Access Compliance Report

Public Rights-of-Way

(Curb Ramps)

Intersection ID: 26464	Main Street: BEVINGTON_PL	Cross Street: ENCLAVE_PL	Location: NE
ADA ID: 93710169160E	Ramp Type: PerpDiag	Initial Pass/Fail: Fail	Overall Compliance: No
		Severity Score: 12.5

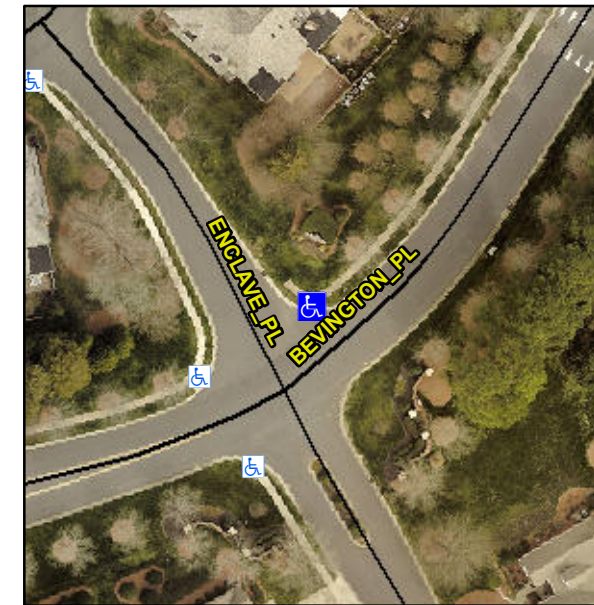
Not Found, R304.5.3

Compliance	Description	Data	Compliance	Description	Data
N/A	Ramp Length (in)	97.0	Yes	Ramp Slope (%)	5.3
Yes	Ramp Width (in)	48.0	No	Ramp XSlope (%)	5.8
N/A	Flare Type LT	N/A	N/A	Flare Type RT	N/A
N/A	Flare Slope LT (%)	N/A	N/A	Flare Slope RT (%)	N/A
N/A	Flare Traversable LT?	N/A	N/A	Flare Traversable RT?	N/A
N/A	Landing Length (in)	N/A	N/A	DWS Provided?	N/A
N/A	Landing Width (in)	N/A	N/A	DWS Contrast?	N/A
N/A	Landing Slope (%)	N/A	N/A	DWS Length (in)	N/A
N/A	Landing X Slope (%)	N/A	N/A	DWS Full Width?	N/A
N/A	Landing Curb? (Y/N)	N/A	N/A	DWS Offset (in)	N/A
N/A	Shared Landing?	N/A			
N/A	Gutter Ponding?	N/A	N/A	Gutter Slope (%)	N/A
N/A	Gutter Lip Ht (in)	N/A	N/A	Gutter X Slope (%)	N/A
N/A	Painted X Walk1?	No	N/A	Painted X Walk2?	No
	X Walk 1 Direction	To SW		X Walk 2 Direction	To S
N/A	X Walk 1 Width (in)	N/A	N/A	X Walk 2 Width (in)	N/A
	X Walk 1 Slope (%)	6.0		X Walk 2 Slope (%)	3.1
	X Walk 1 X Slope (%)	0.9		X Walk 2 X Slope (%)	7.0

Remove & Replace Curb Ramp With Two New Directional Ramps or Equivalent.
